Glenwood MS Envelope Renovation
Addendum Number 1
3/13/2020

To: All Plan Holders
Project: HCPSS Glenwood MS Envelope Renovation
Re: Addendum Number 1

To the Contract Drawings and Specifications for the referenced project as dated below, as prepared by Hord Coplan Macht Architects in conjunction with OAK Contracting LLC, this addendum includes changes and clarifications to the Contract Documents as follows:

Glenwood MS Envelope Renovation
HCM Project No. 219169.00

9A FIRST FLOOR DEMOLITION PLAN
A1.01 1/16" = 1'-0"

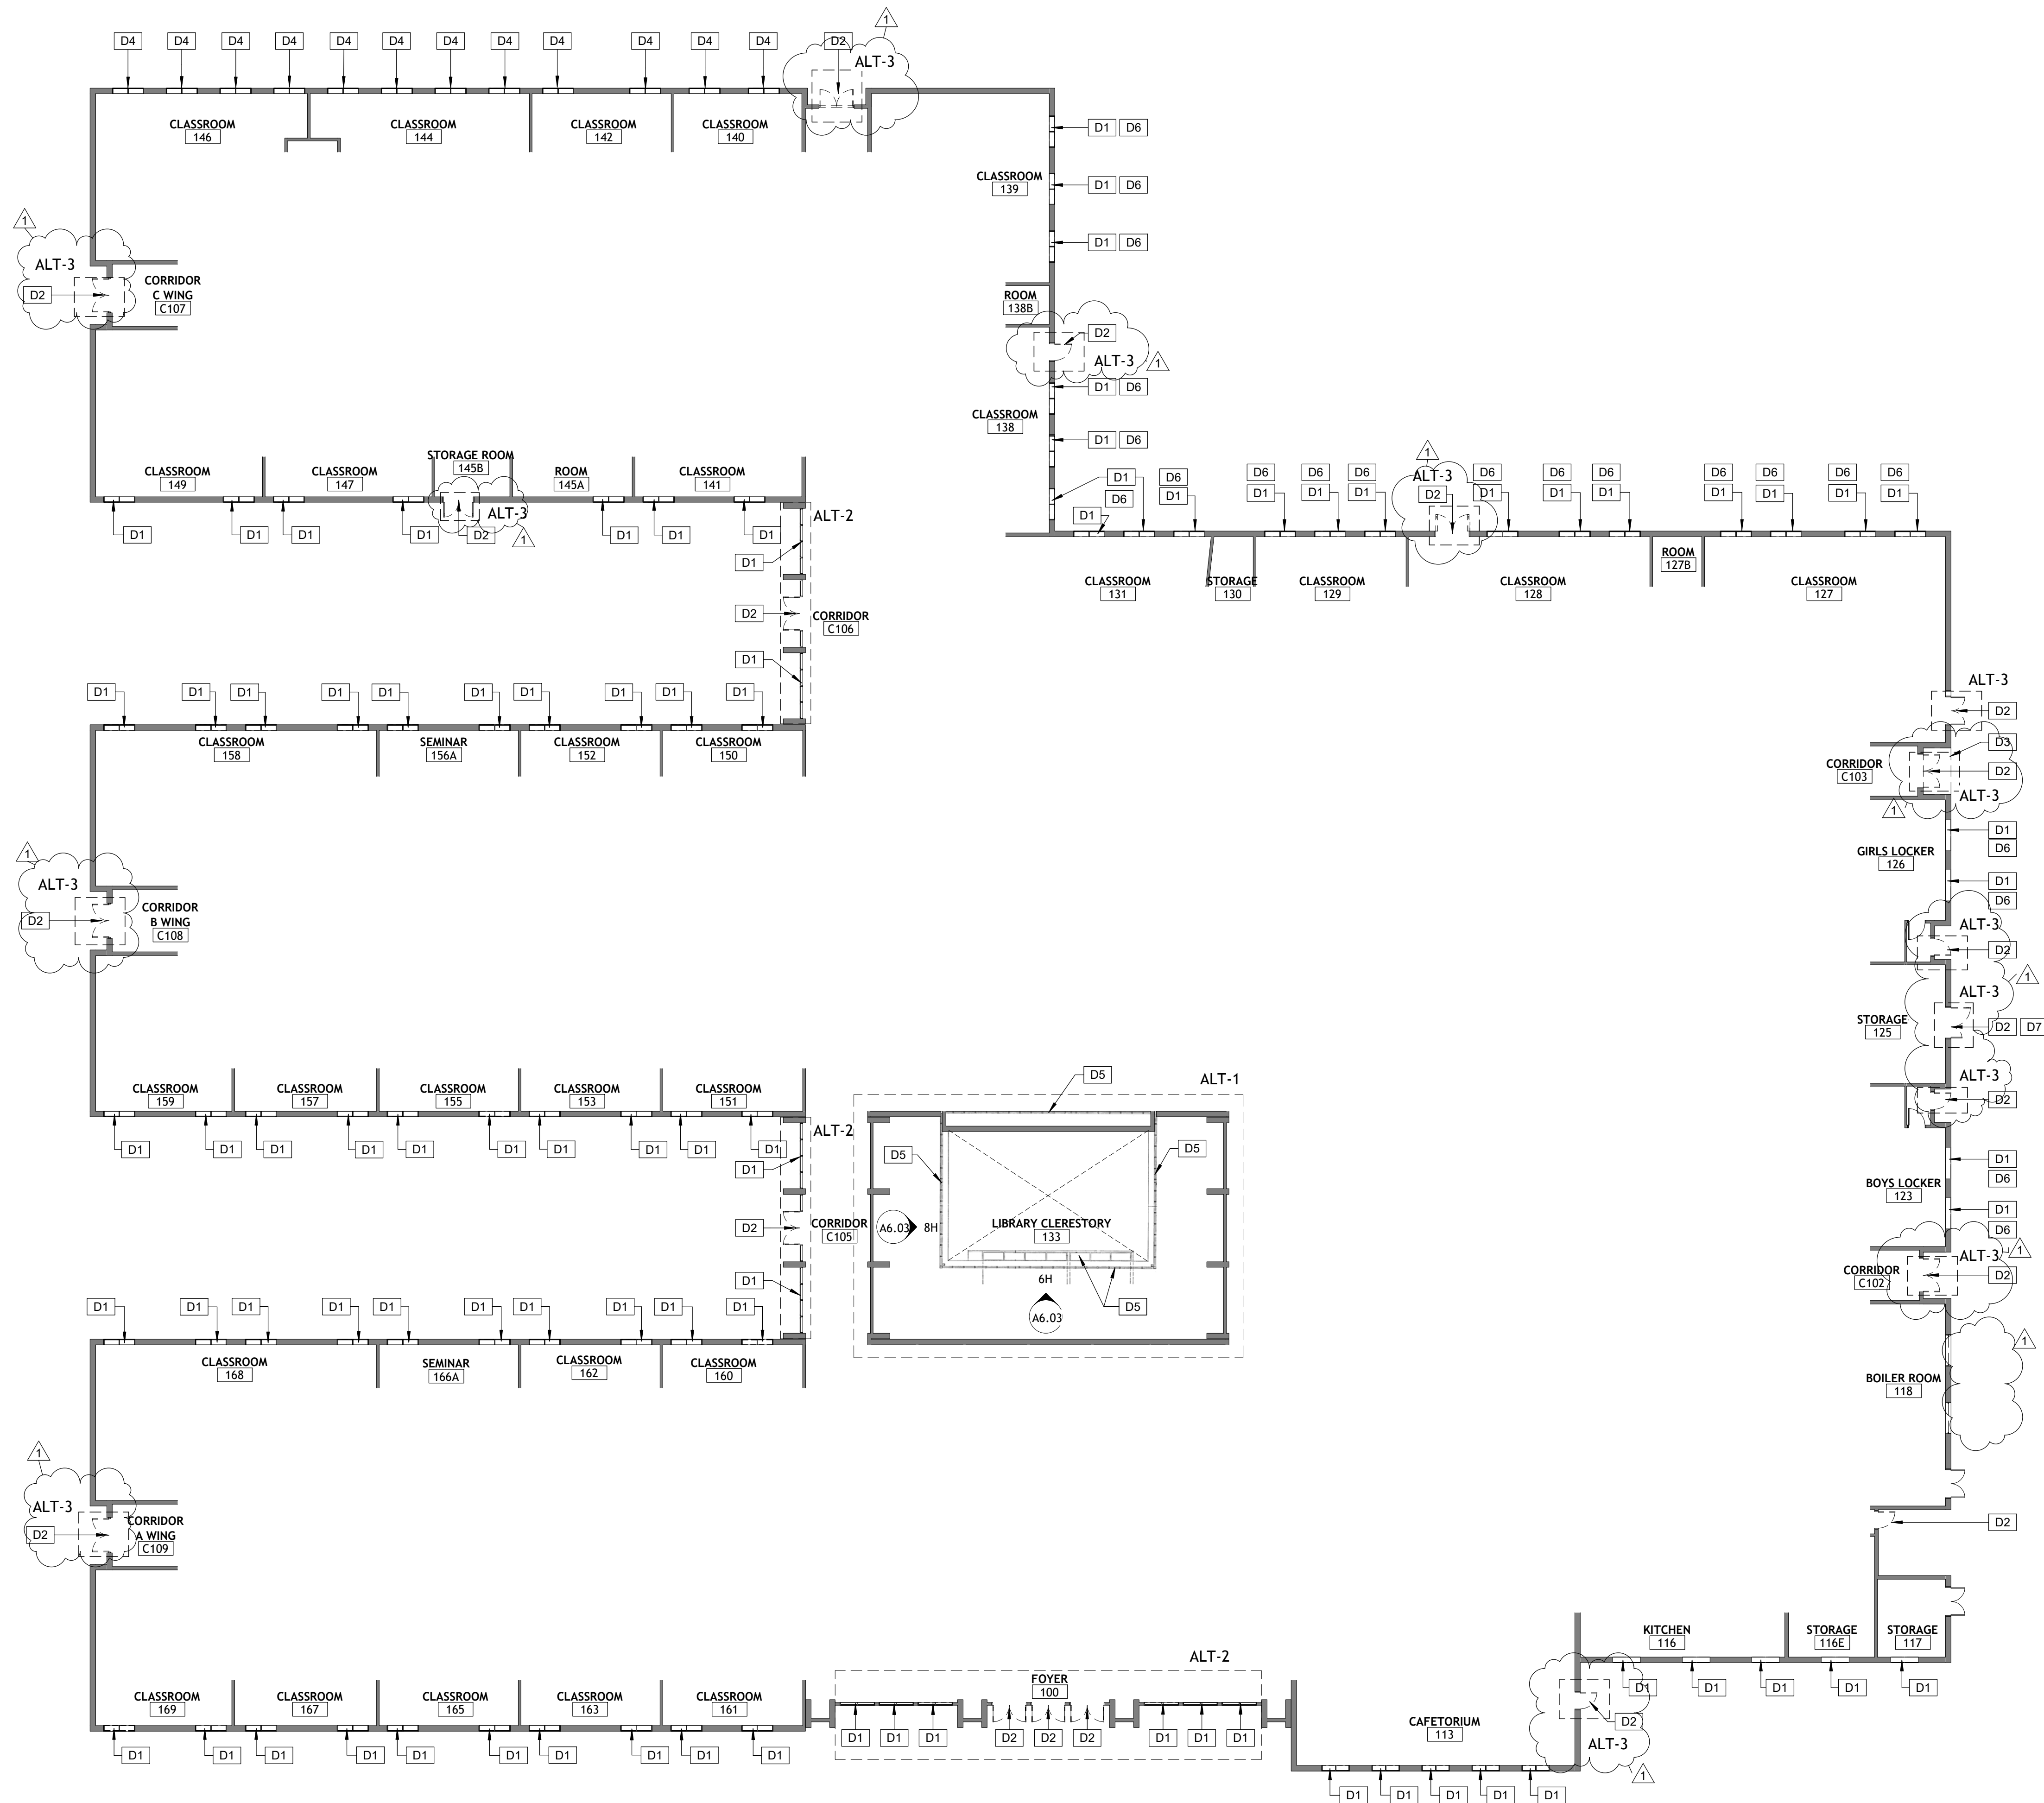
Please clarify drawing A1.01 Demolition Keynote includes "ALT – 3" adjacent to the note for D2. Are all D2s Alt #3?

Demolition keynote D6, "Remove Cast Stone Sill" on page A1.01 states that it is part of Alt #1. According to the alternates on the Bid Proposal, Alt #1 is about the clerestory windows. Please advise if this should be on base bid or any of the alternates?

Demolition keynote D7, "Remove Existing Thru Wall Flashing and Three Brick Courses" on page A1.01 states that it is part of Alt #3. Keynote N2 on page A2.01 states that this should be on Alt #2. Please advise if this should be on Alt #2 or #3?

Demo floor plan on sheet A1.01 calls out demo of windows at boiler room. However, on the floor plan on sheet A2.01 does not call out the new replacement windows. Please clarify to replace with new and type of window it is or leave as existing?

This will be clarified in drawing A1.01 in Addendum #1.

Removal and replacement of Cast Stone Sills are part of the base bid, which will be clarified on sheet A1.01 of Addendum #1.

Alternates will be clarified on Sheet A1.01 of Addendum #1.

9A FLOOR PLAN
A2.01 1/16" = 1'-0"

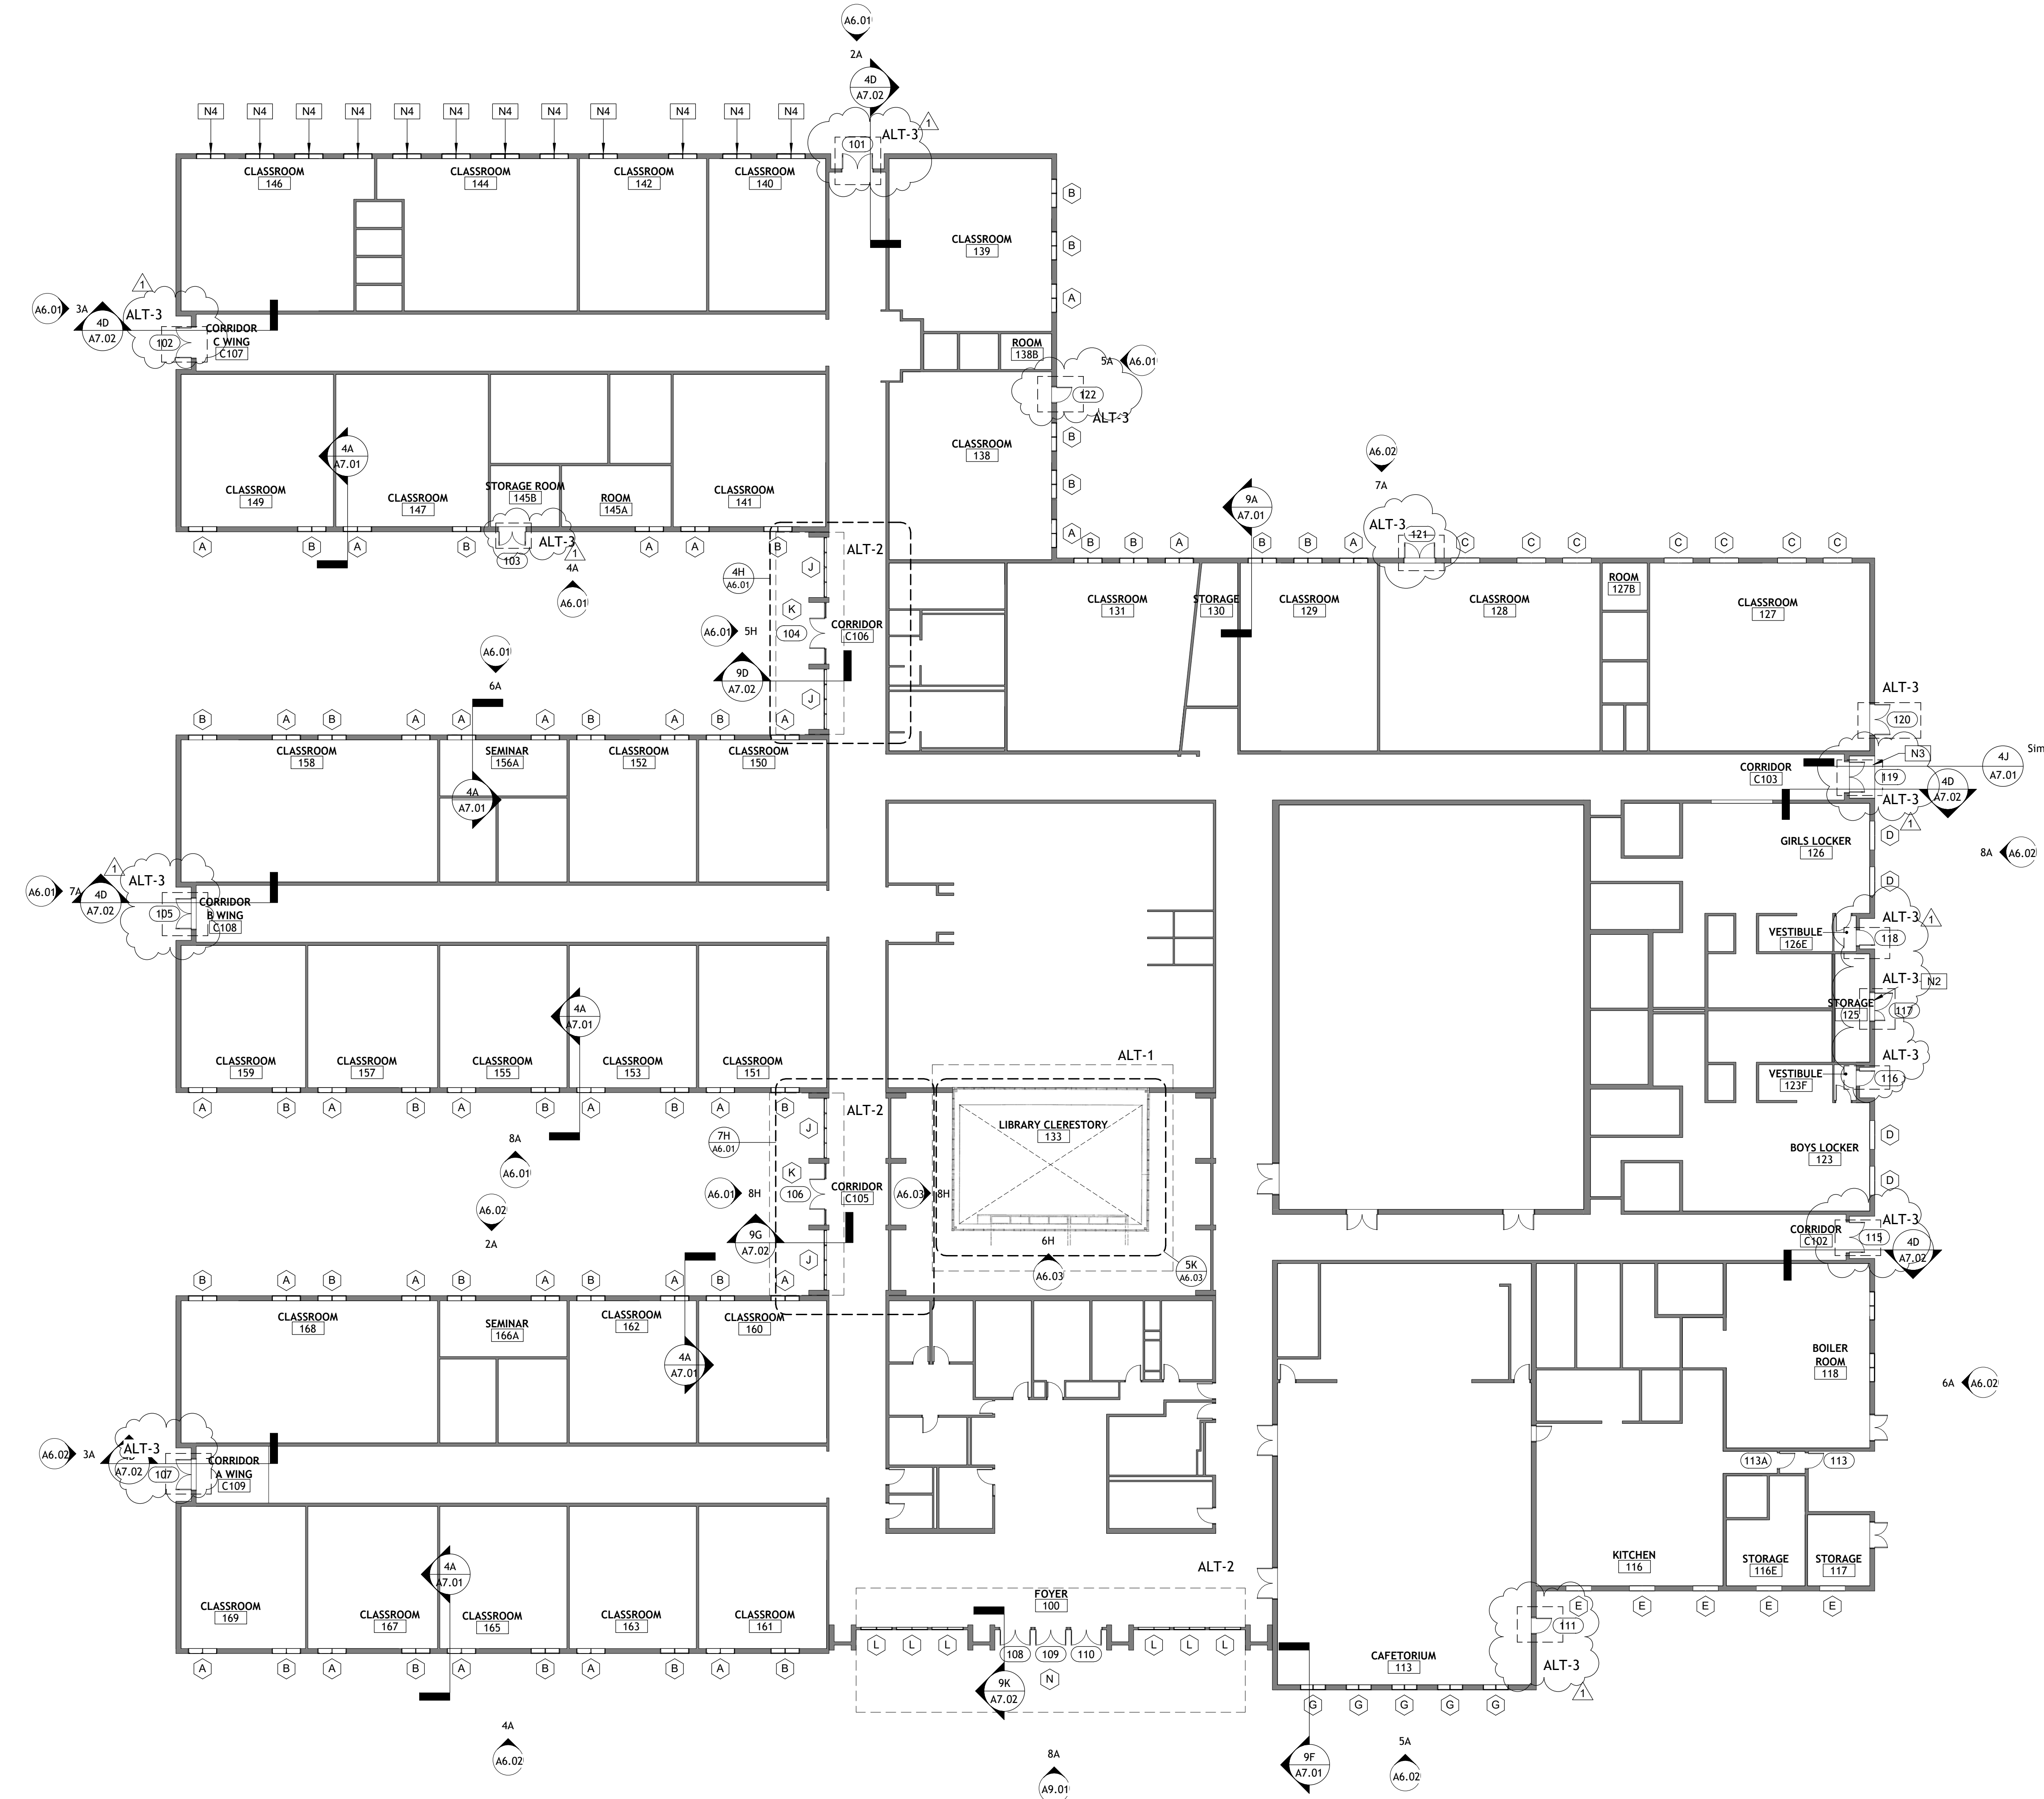
KEYNOTES	
N2	THRU-WALL FLASHING & 3 BRICK COURSES. PROVIDE BRICK.
N3	REMOVE AND REPOUR CONCRETE SIDEWALK TO MEET ADA REQUIREMENTS.
N4	PROVIDED EXTERIOR AND INTERIOR SEALANT AND BACKER ROD.

See Hardware Set below, and also on revised Hardware Schedule on Sheet A2.01 of Addendum #1.
